BID #709 – Ventura College STEM Program Building Improvements

ADDENDUM 001, dated 05/15/2025

DRAWING changes and clarifications noted as Addendum 01 and dated 05/15/2025:

TRENCH DRAIN

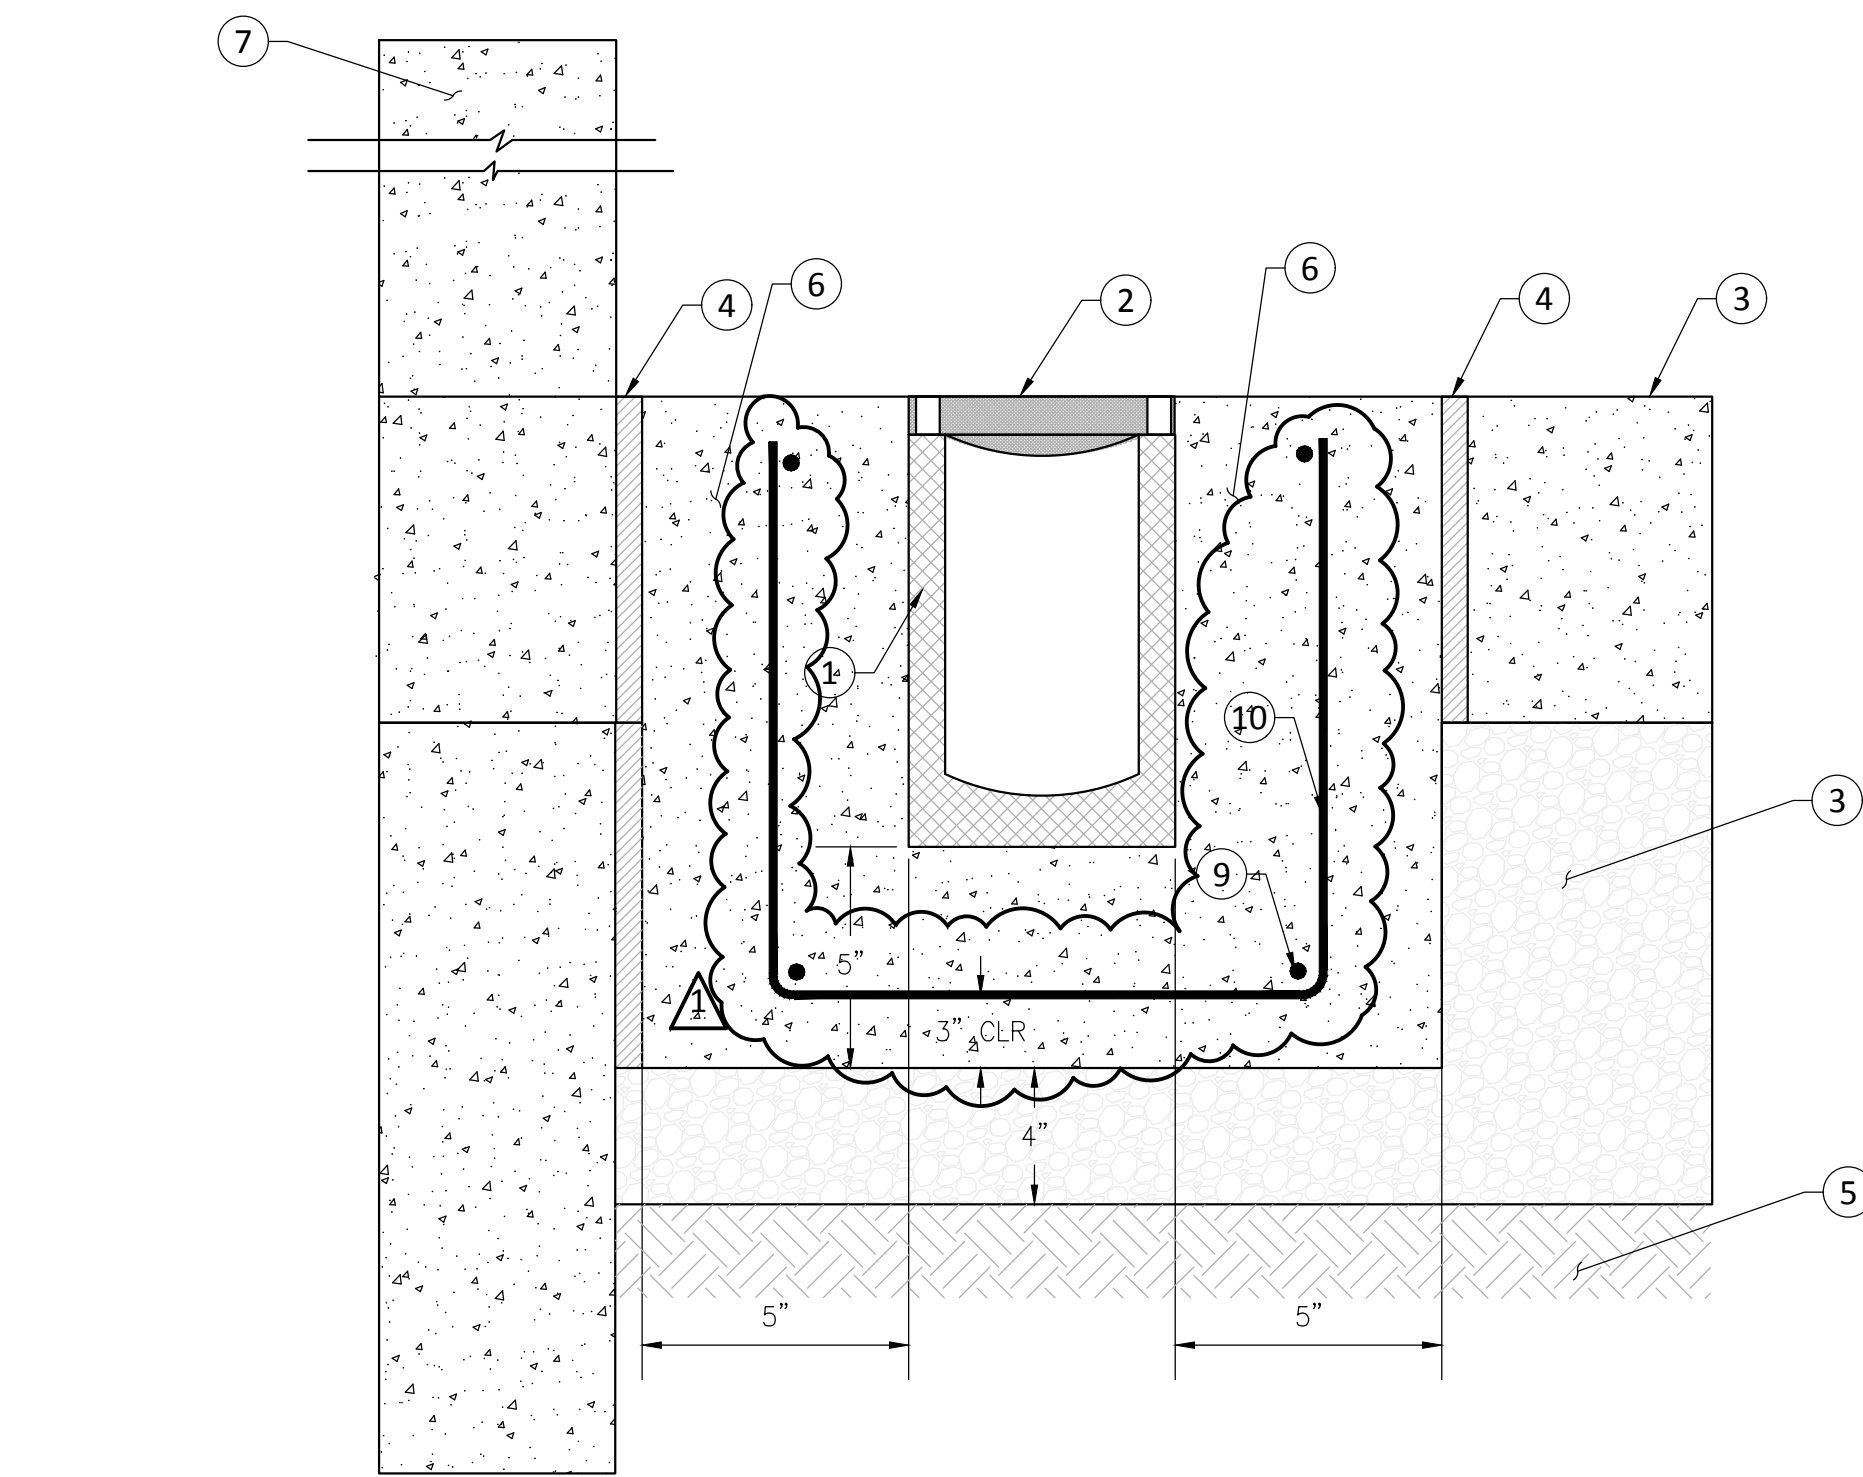
C5.1 – ADDED REINFORCEMENT TO TRENCH DRAIN DETAIL 12/C5.1, NEW CONCRETE V-GUTTER DETAIL 18/C5.1

C6.1
DATE: SHEET 5 OF

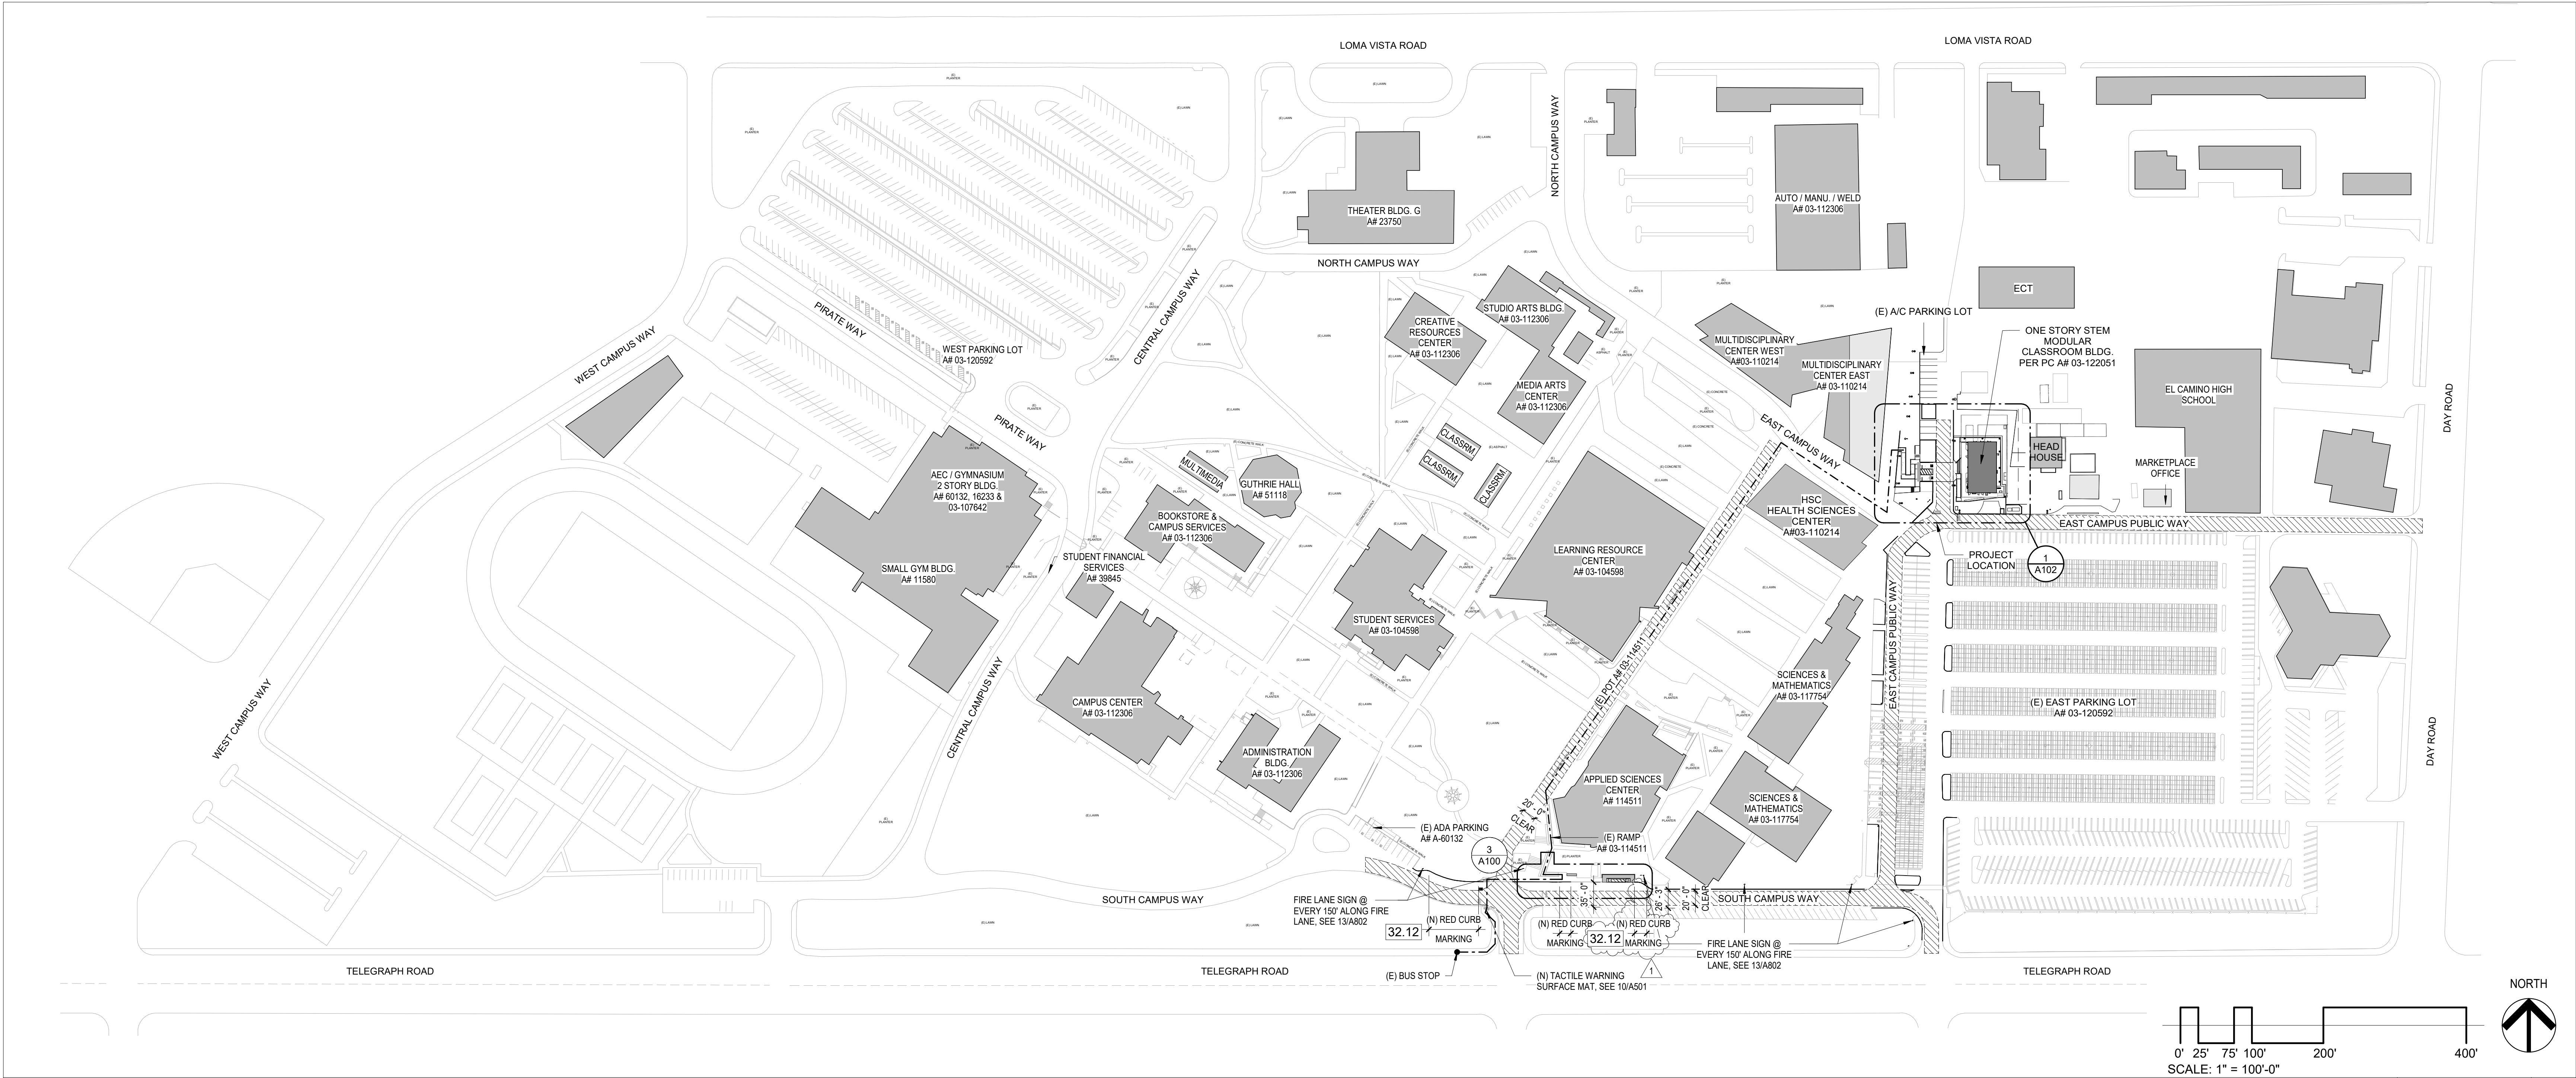
C6.1 – EROSION CONTROL PLAN FOR DROP-OFF AREA

CAMPUS SITE PLAN &
STUDENT DROP OFF
SITE PLAN

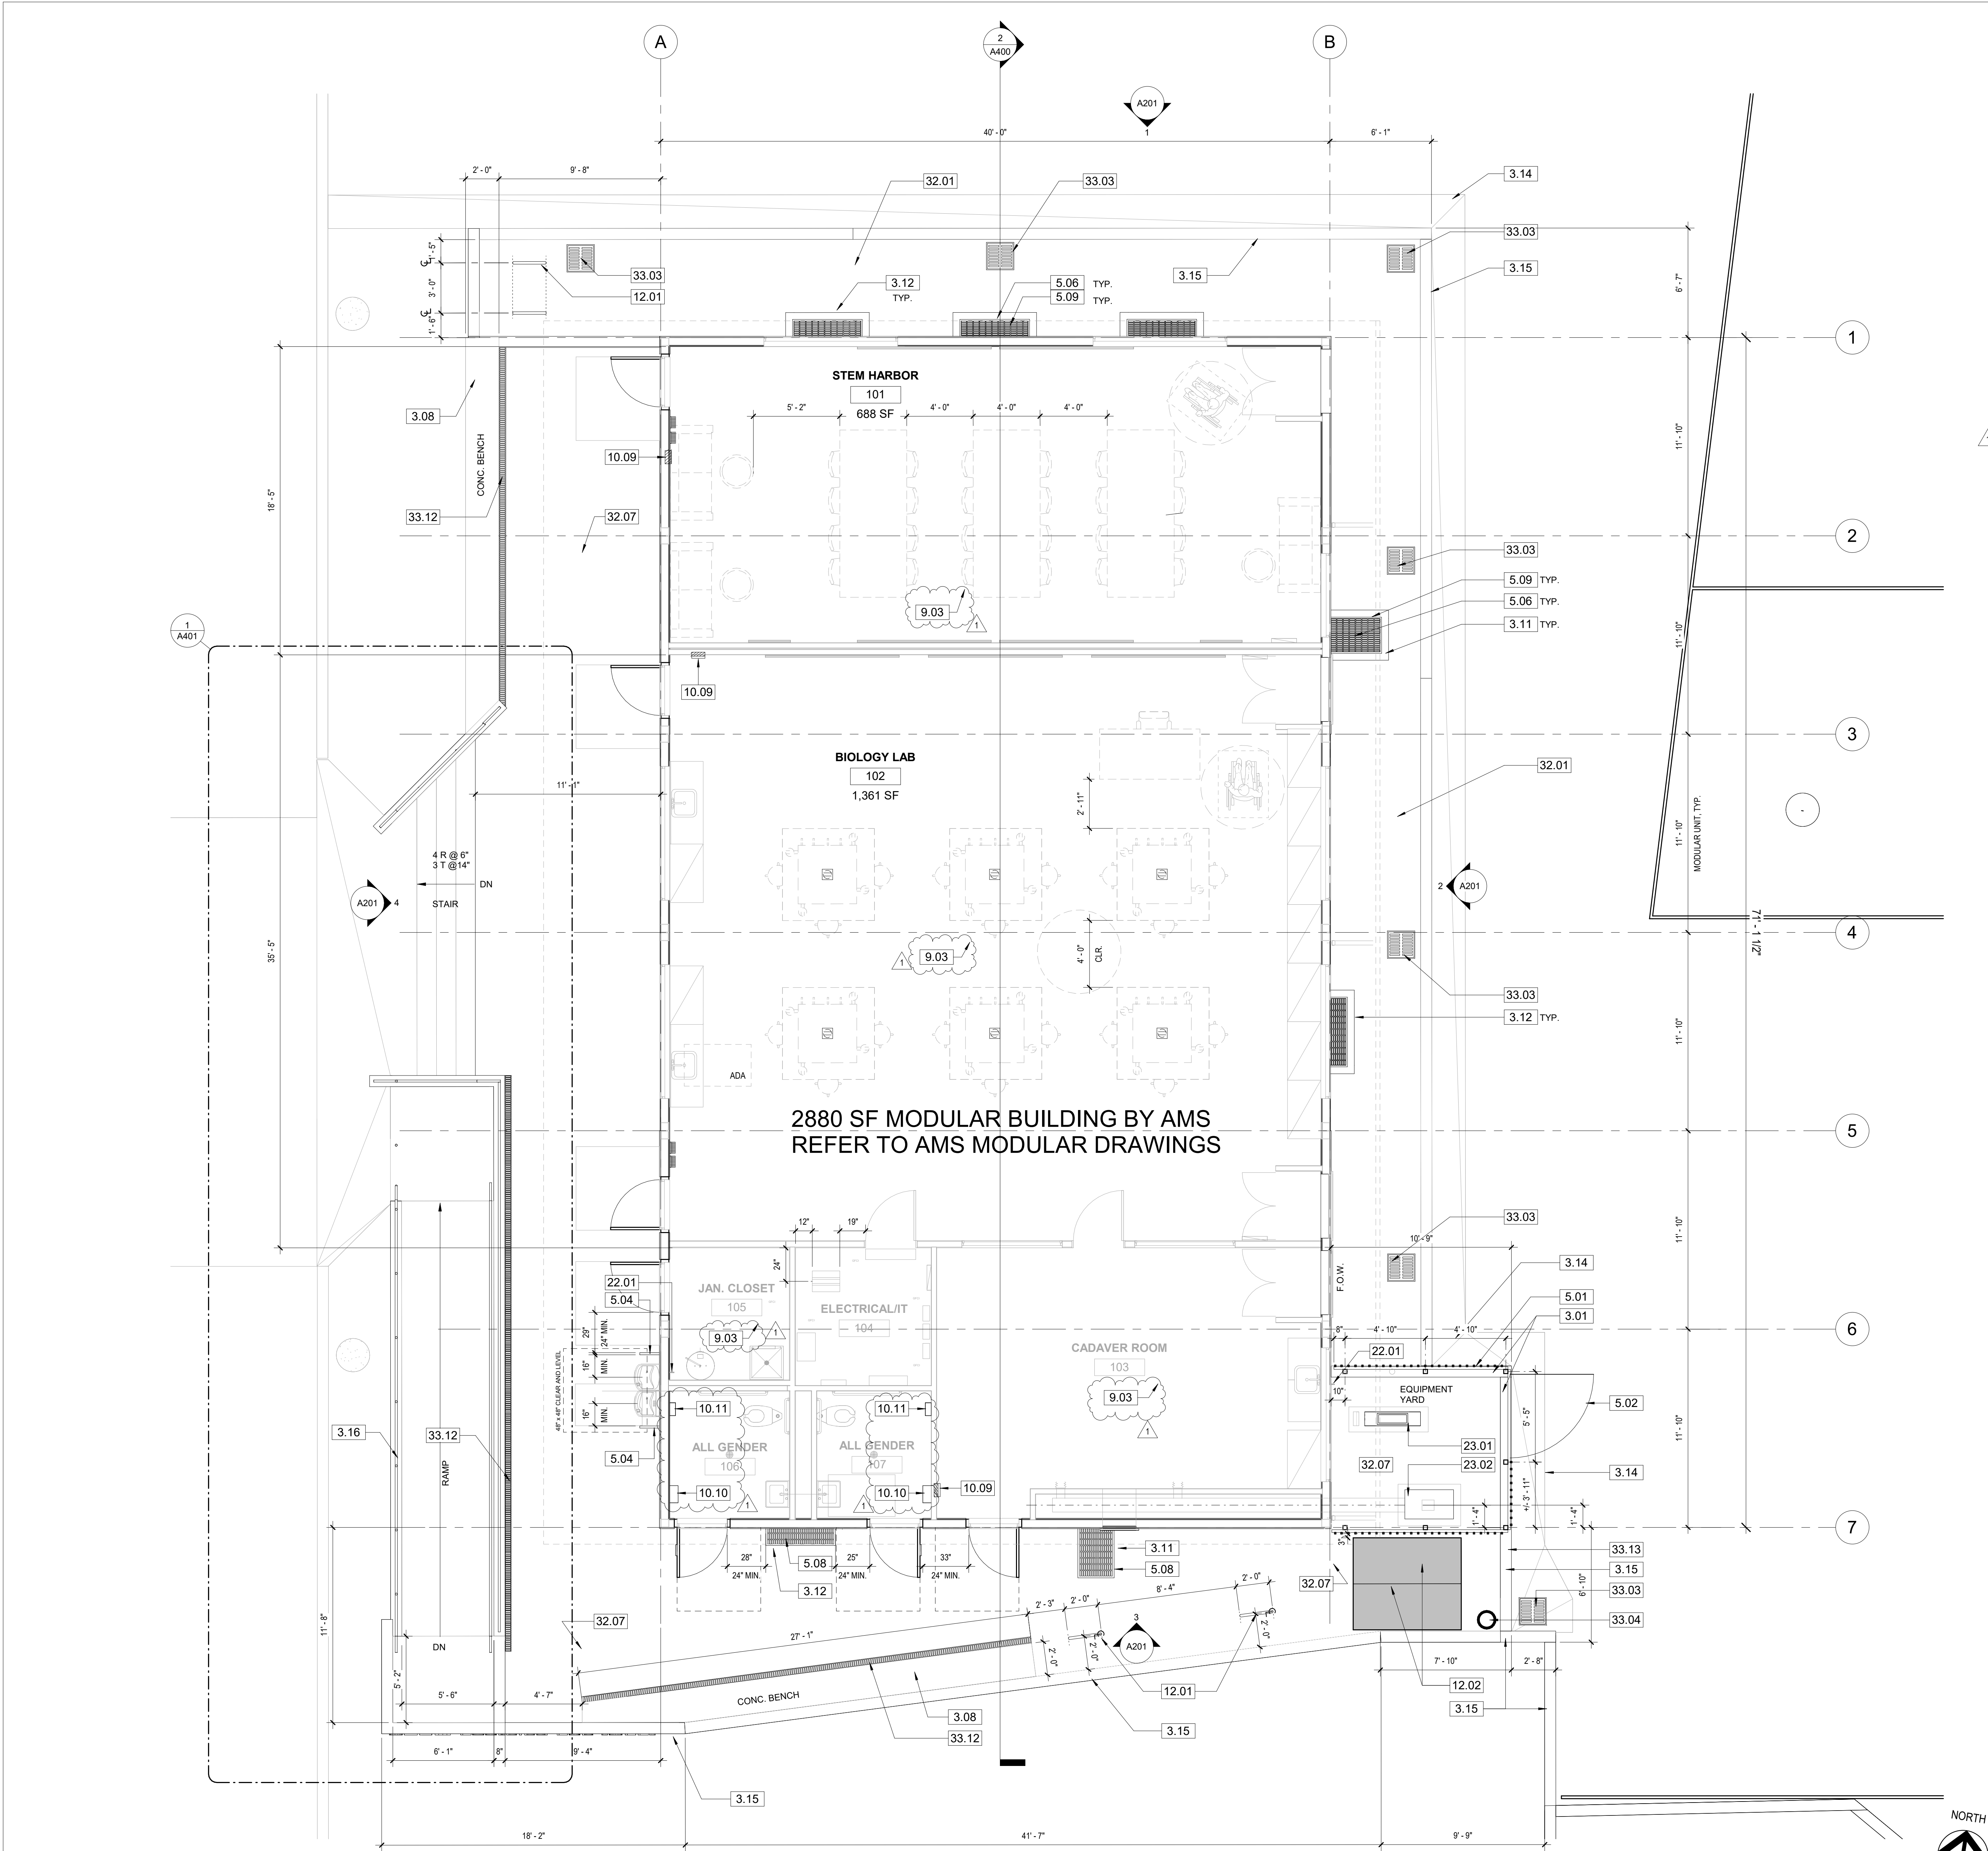
A100 – CAMPUS SITE PLAN & STUDENT DROP OFF SITE PLAN: CONCRETE BENCH ADDED.

FLOOR PLAN

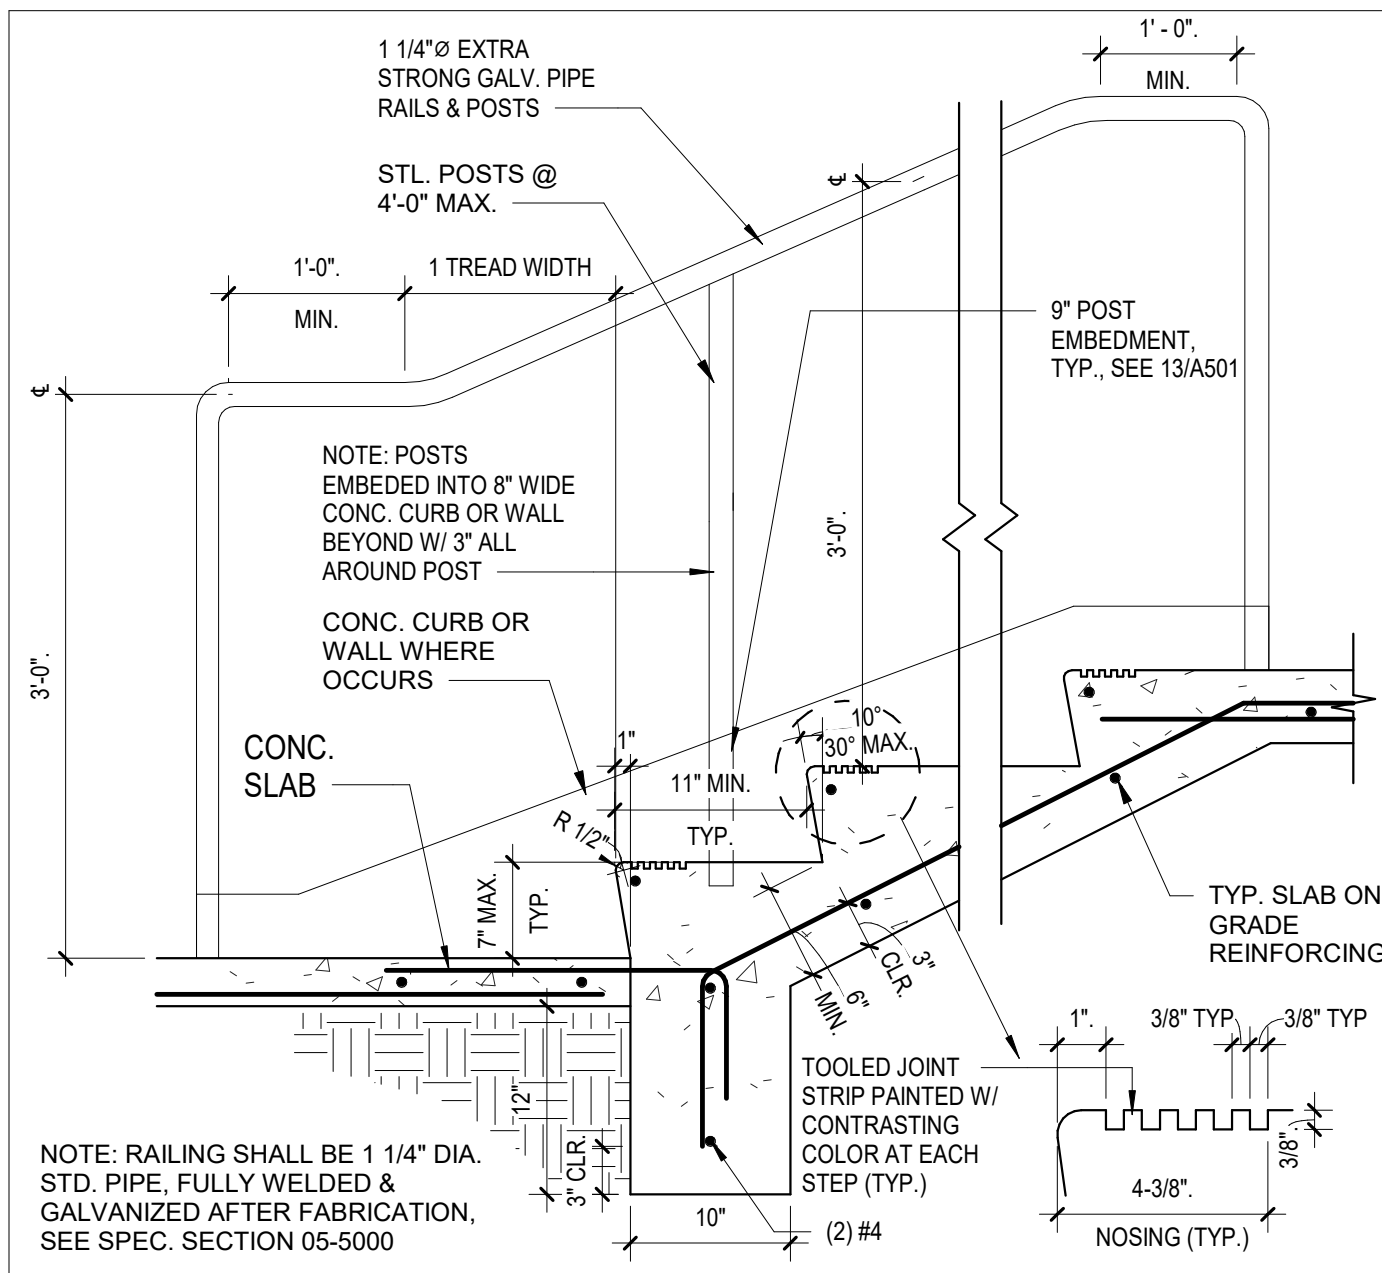
A111 – FLOOR PLAN: TOILET ACCESSORIES ADDED.
